CHANGE ORDER

July 2, 2024

21-08

Water Treatment Plant Trunk Water Main Improvements

UTILITY PLAN AND PROFILE

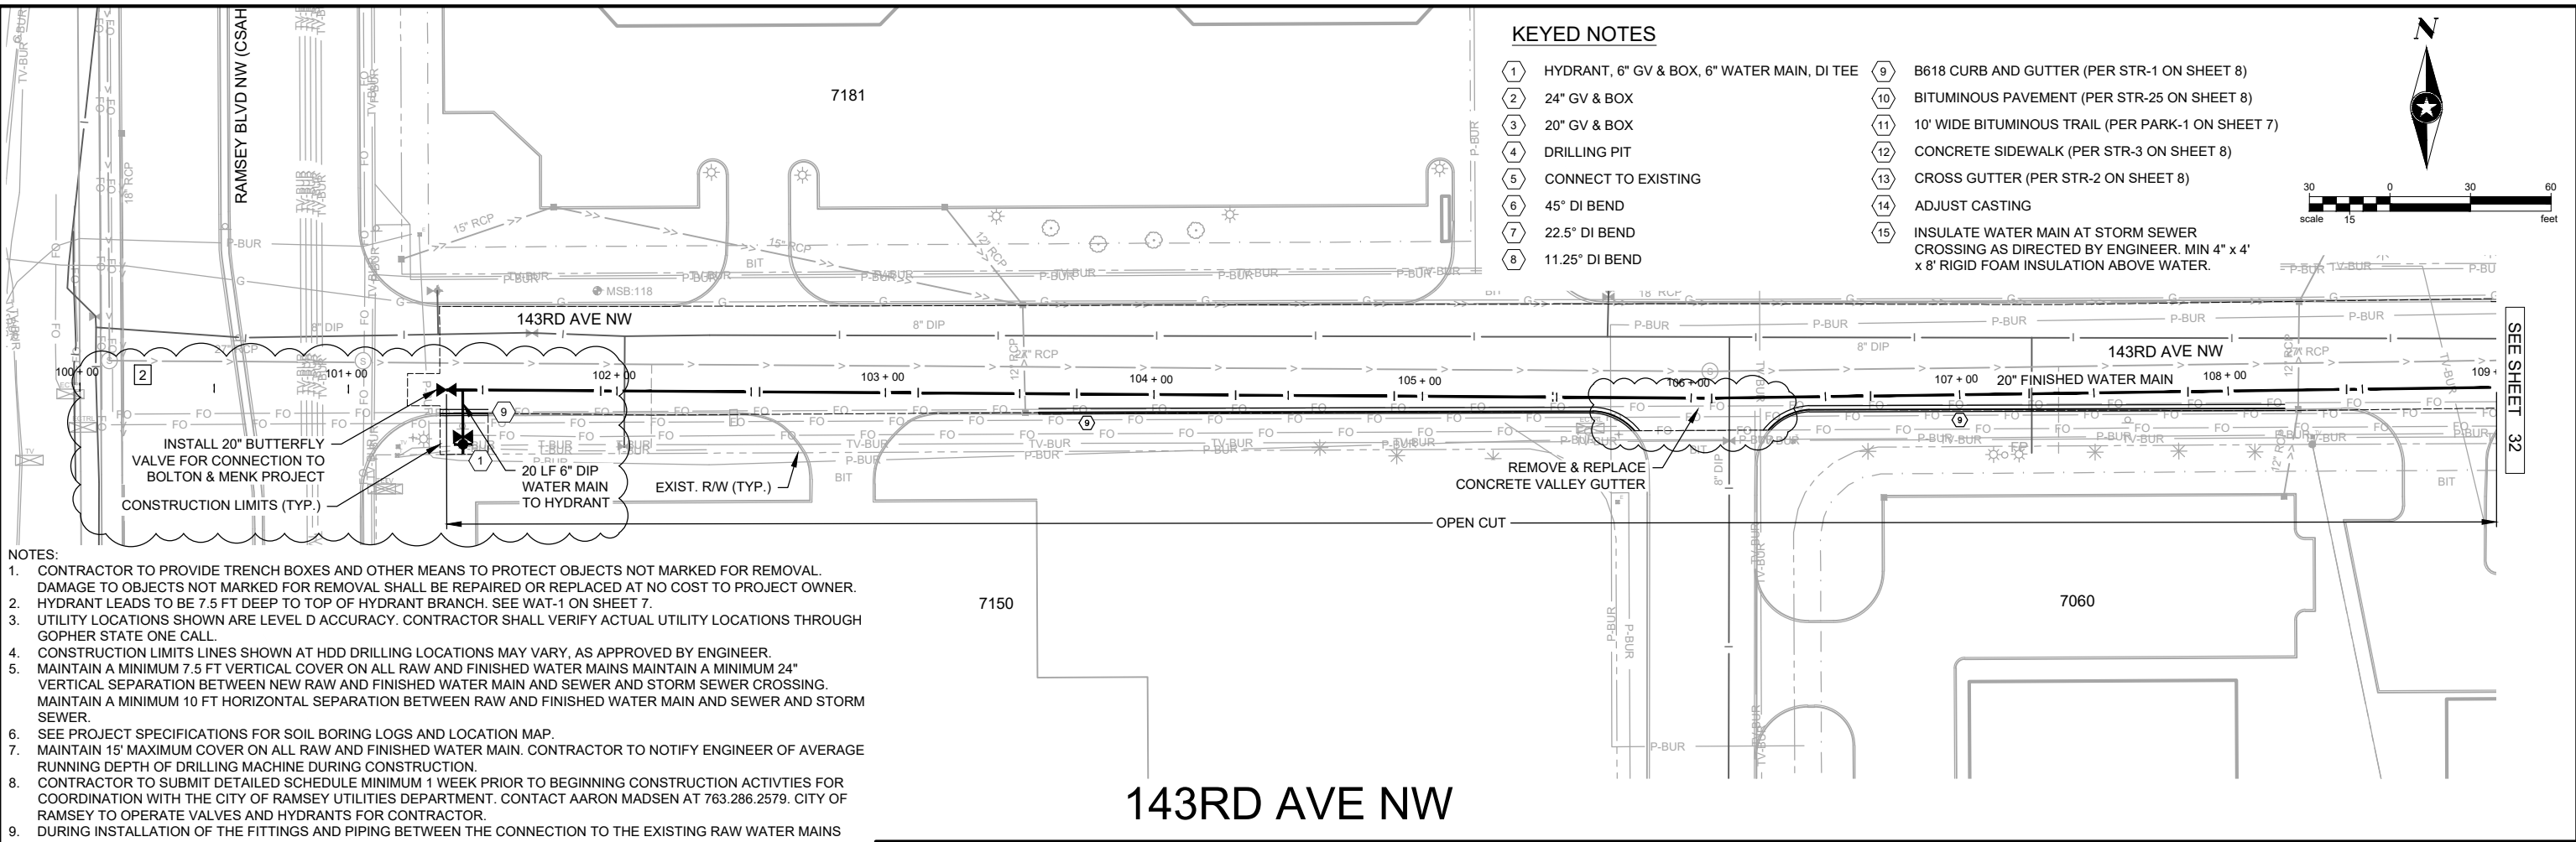
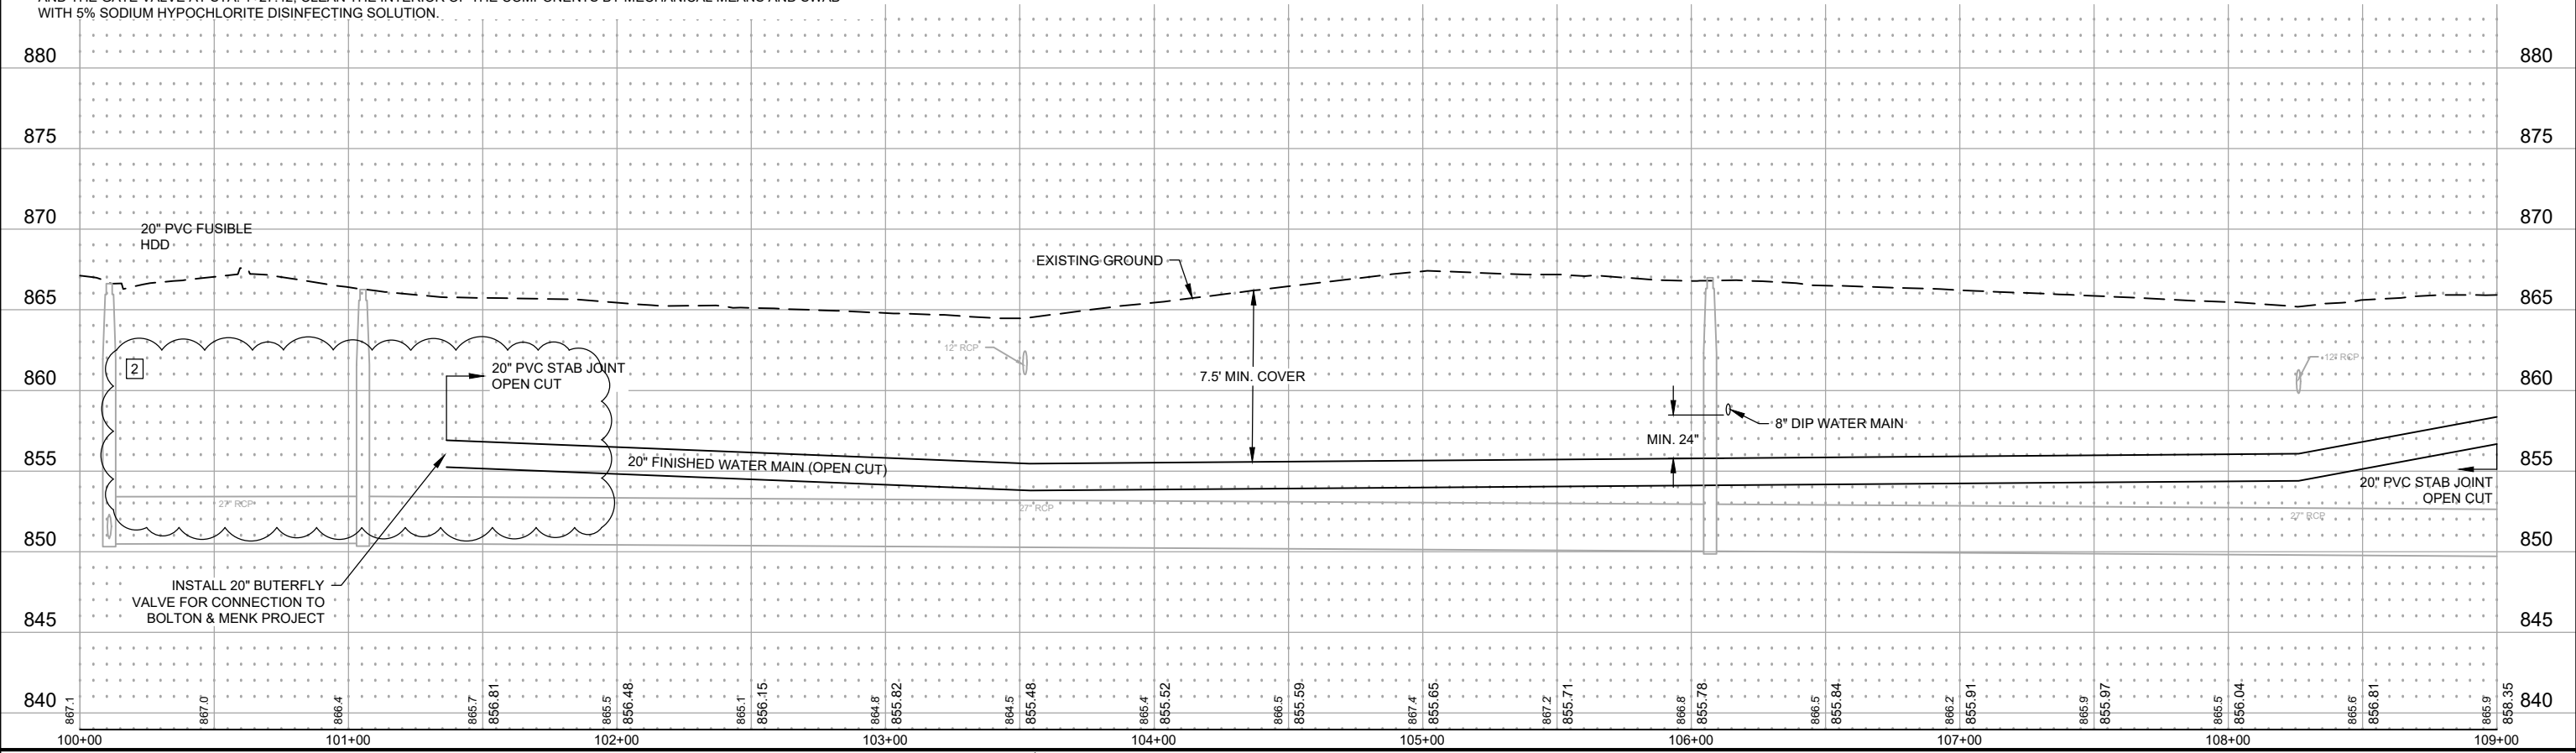
The attached plan sheet shows the changes at the 143rd/Ramsey Blvd intersection. It did require some additional water main elements to make this change, such as hydrant, valves, fittings, etc.

The following items are related to this change order:

1. 20" HDD across Ramsey Blvd at 143rd St. is being eliminated from the project.
2. The project will now bring the 20" open cut up to the Eastern ROW line of Ramsey Blvd where the 20" butterfly valve will be installed for testing prior to Ramsey Gateway connection with their project in Spring 2025.
3. Increase in Class 5 item is intended to pay for common excavation, subgrade prep and salvage & placement of reclaimed material.
4. Concrete work (6" walk and truncated domes) were add to the project at 147th and Bunker Lake Blvd. at Citys' request, which was not included in the bid.

- Revised plan sheet 31.
